Access Compliance Report

Public Rights-of-Way

(Curb Ramps)

Intersection ID: 10012605	Main Street: MEADOW_KNOLL_DR	Cross Street: N/A	Location: S
ADA ID: 67F38729979E	Ramp Type: PerpDiag	Initial Pass/Fail: Pass	Overall Compliance: No
Severity Score: 17.75			
Codes/Mitigation Info/Possible Solution		Field Measurements/Component Compliance

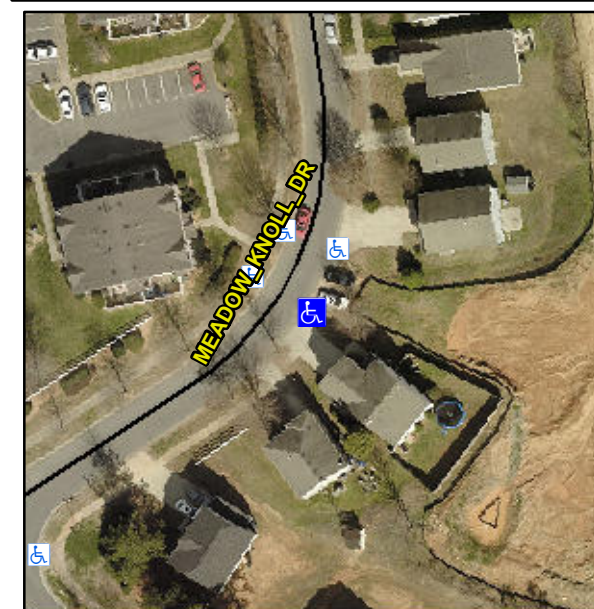
Not Found, R304.5.3, R305.1.4, R305.2, R302.7.2

Compliance	Description	Data	Compliance	Description	Data
N/A	Ramp Length (in)	68.0	Yes	Ramp Slope (%)	7.2
Yes	Ramp Width (in)	51.5	Yes	Ramp XSlope (%)	2.8
N/A	Flare Type LT	Sloped	N/A	Flare Type RT	N/A
N/A	Flare Slope LT (%)	15.1	N/A	Flare Slope RT (%)	5.3
N/A	Flare Traversable LT?	No	N/A	Flare Traversable RT?	No
Yes	Landing Length (in)	58.5	Yes	DWS Provided?	Yes
Yes	Landing Width (in)	51.5	Yes	DWS Contrast?	Yes
Yes	Landing Slope (%)	1.9	Yes	DWS Length (in)	25.5
No	Landing X Slope (%)	3.6	No	DWS Full Width?	No
N/A	Landing Curb? (Y/N)	No	No	DWS Offset (in)	6.0
N/A	Shared Landing?	No			
Yes	Gutter Ponding?	No	Yes	Gutter Slope (%)	2.1
No	Gutter Lip Ht (in)	1.0	Yes	Gutter X Slope (%)	0.5
N/A	Painted X Walk1?	No	N/A	Painted X Walk2?	No
	X Walk 1 Direction	To NE		X Walk 2 Direction	To NW
N/A	X Walk 1 Width (in)	N/A	N/A	X Walk 2 Width (in)	N/A
	X Walk 1 Slope (%)	1.3		X Walk 2 Slope (%)	2.6
	X Walk 1 X Slope (%)	5.4		X Walk 2 X Slope (%)	2.6

N/A	Ramp inside XWalk1?	N/A	N/A	Ramp inside XWalk2?	N/A
	Road Slope (%)	3.4	N/A	Clear Space?	Yes
	Road X Slope (%)	0.0	N/A	Clear Space to XWalk (in)	N/A
Yes	Any Obstructions?	No	Yes	Storm Grate/Utility Hazard?	No
	Obstruction Type			Storm Grate/Utility Type	
		N/A			N/A
		Yes		Surface Condition? (G/P)	Good

Remove & Replace Curb Ramp With Two New Directional Ramps or Equivalent.
